Proposed secondary dwelling to residence at
42 Pringle Ave Belrose
for John and Therese Hajtkian

date:	scale	dwg. no.
July 2018	1: 200	355.1A

THIS PLAN TO BE READ IN CONJUNCTION WITH
MOD2019/0091
NORTHERN BEACHES COUNCIL

Newbuild Design and Drafting Robert Geoghegan 17 Jocelyn Street North Curl Curl 2099 m. 0419907222 e. robge@bigpond.com		
PROPOSED SECONDARY DWELLING TO SINGLE RESIDENCE 42 PRINGLE AVE BEUROSE FOR JOHN & THERESE HAJAKIAN		
date	scale	dwg.no.
July 2018	1:100	355-3A

PRINGLE AVE

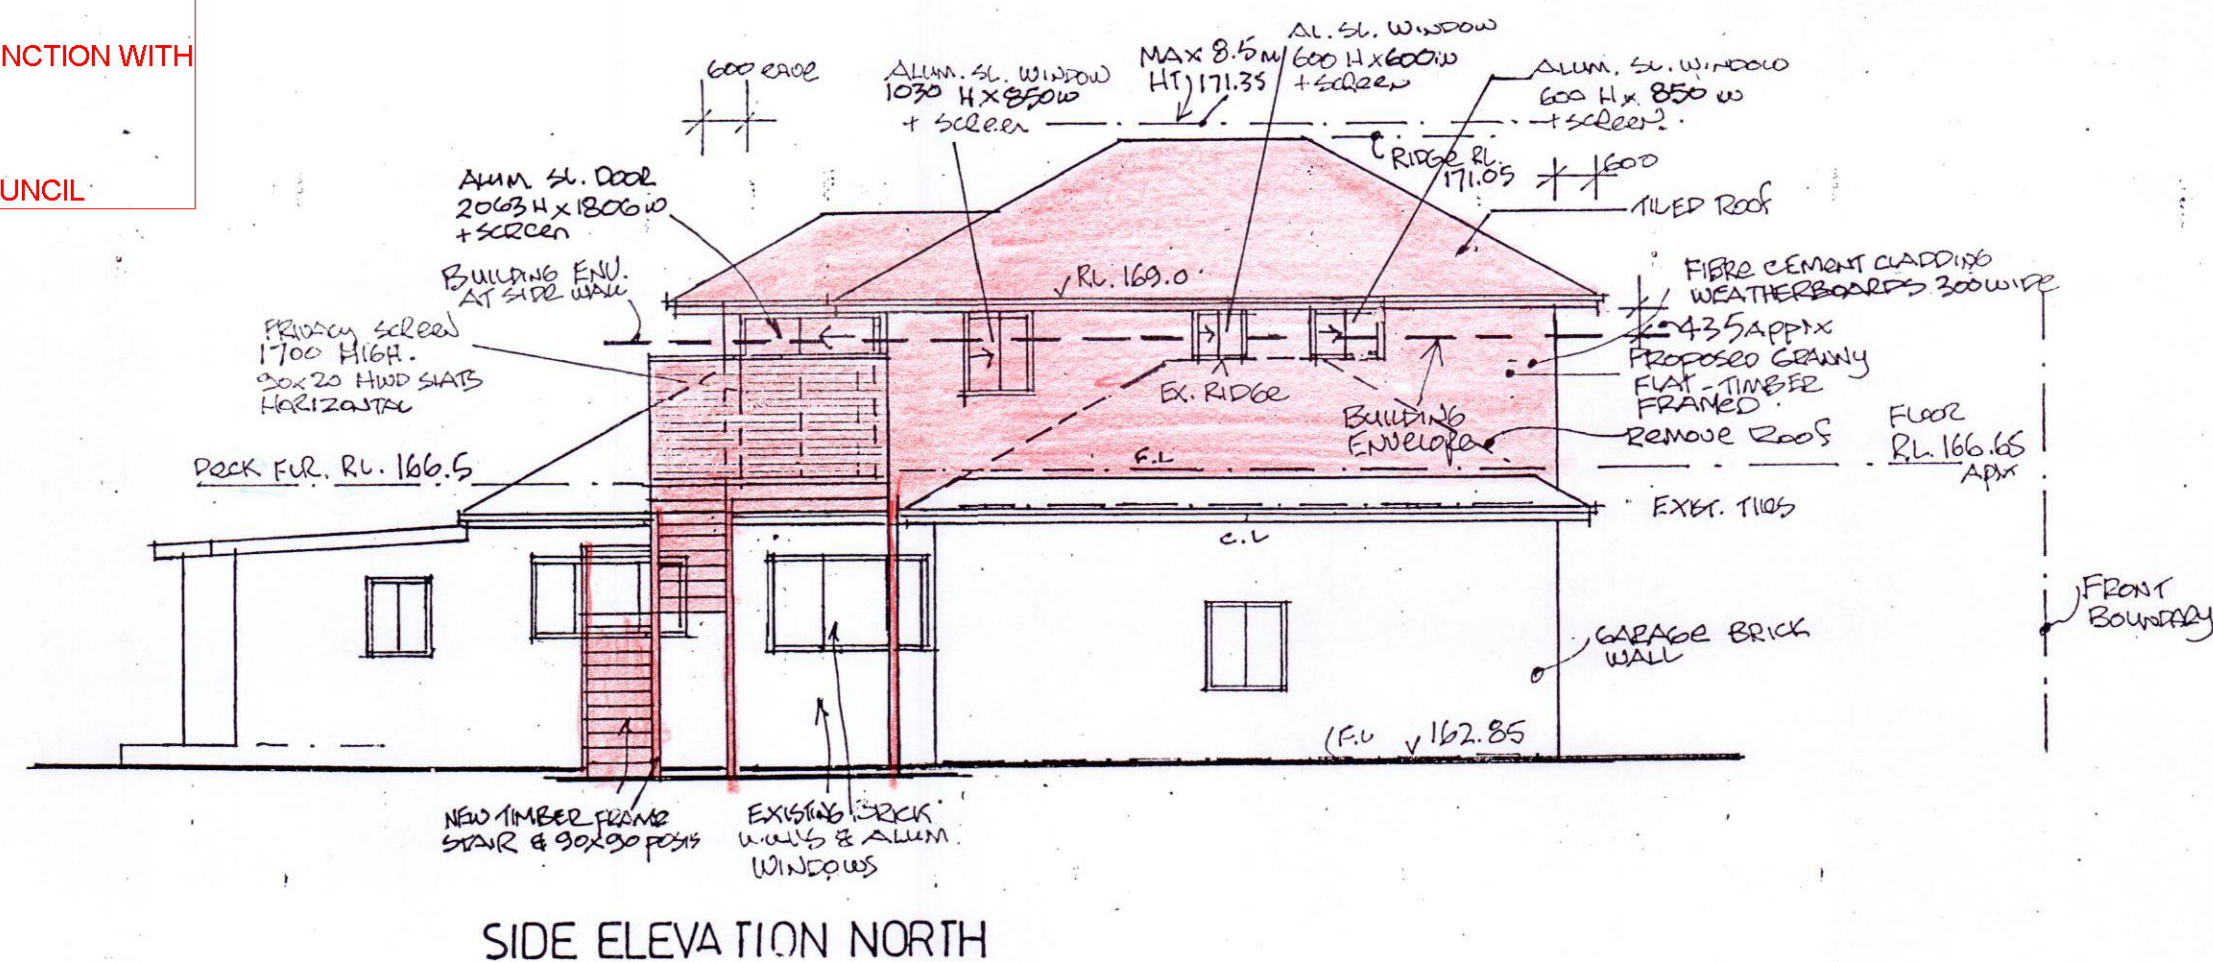
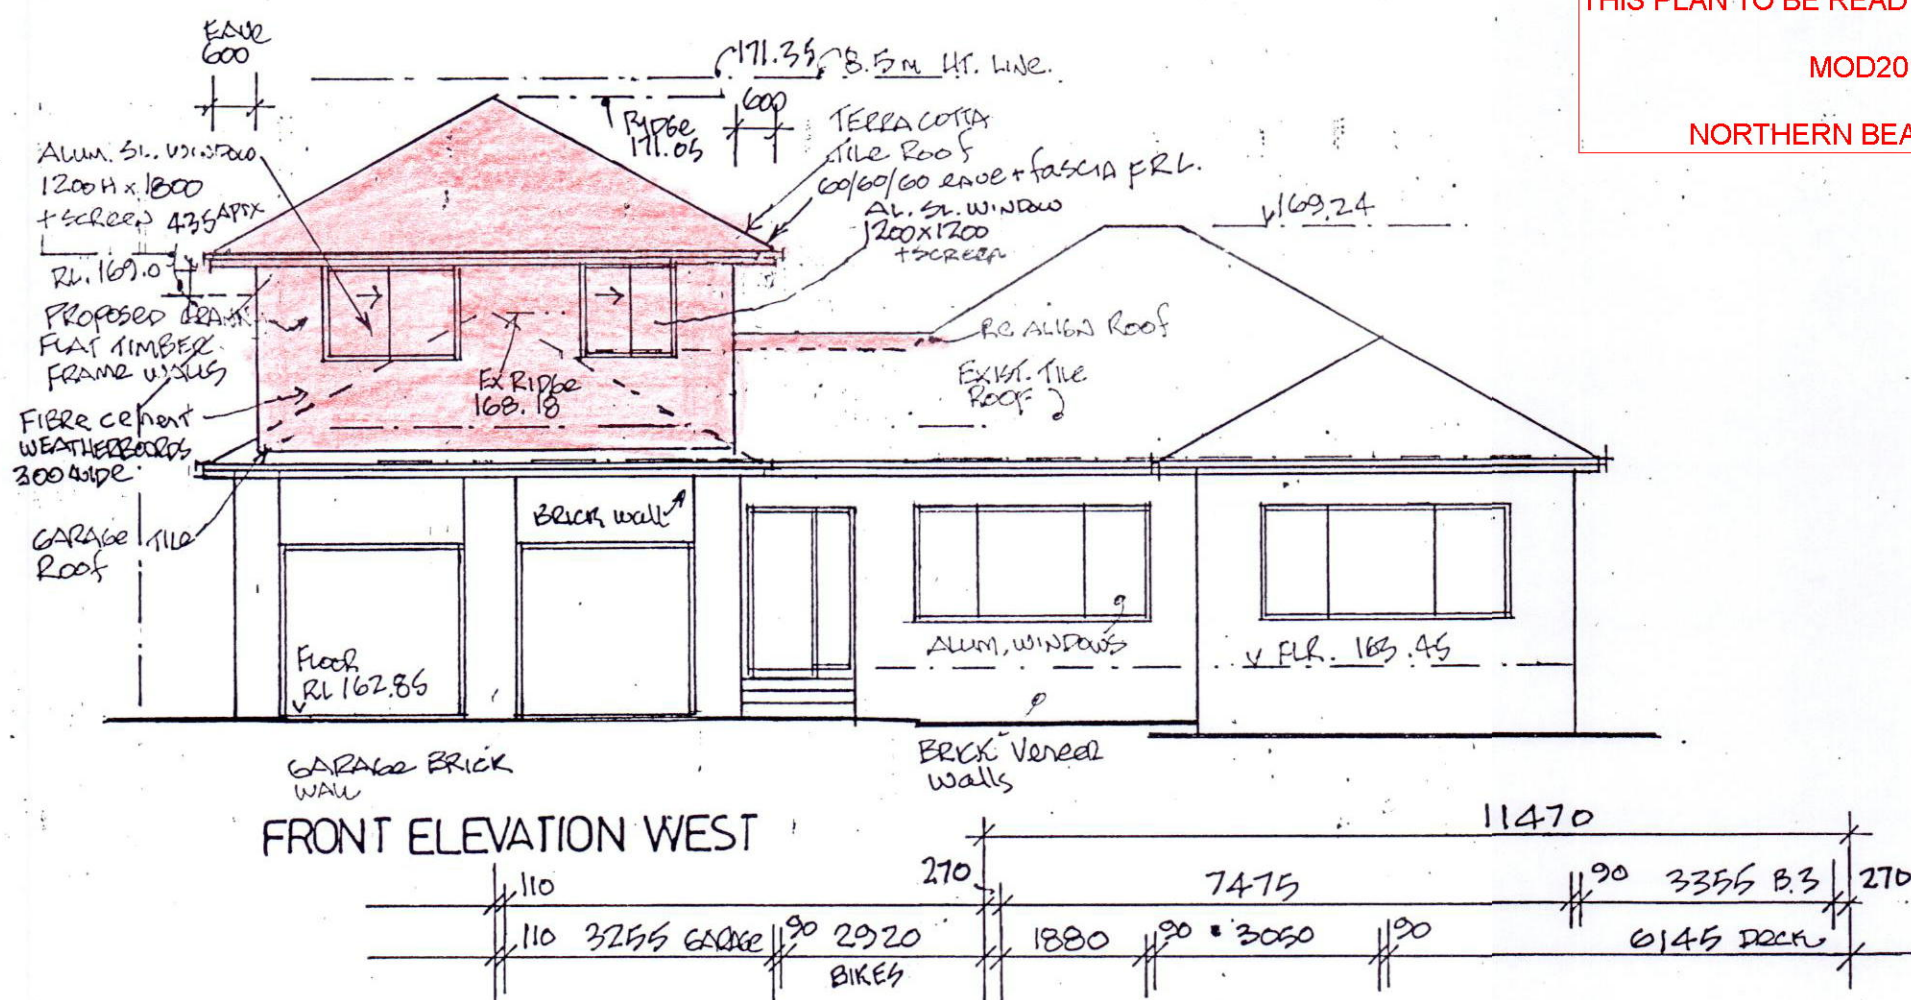
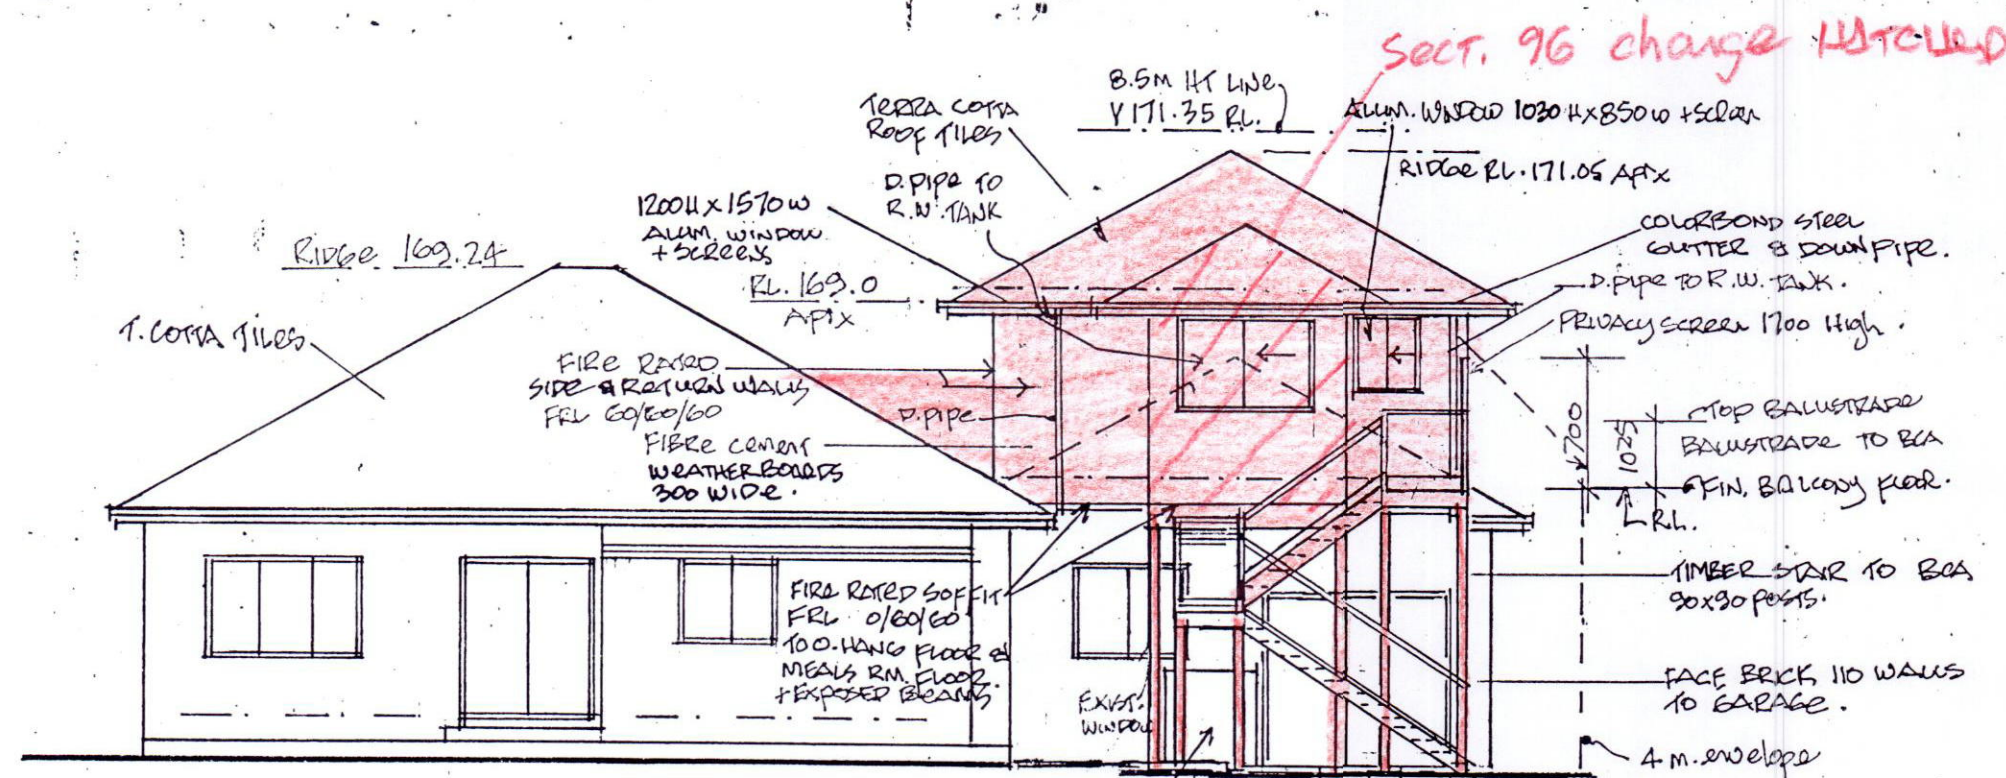
28.2.19	A	Due to fire separation 1200 Road, Bug-Bug, MEALS ROOM MOVED NORTH BY APPROX. 1155mm TO COMPLY WITH FIRE RGS.
DATE	NO	AMENDMENT
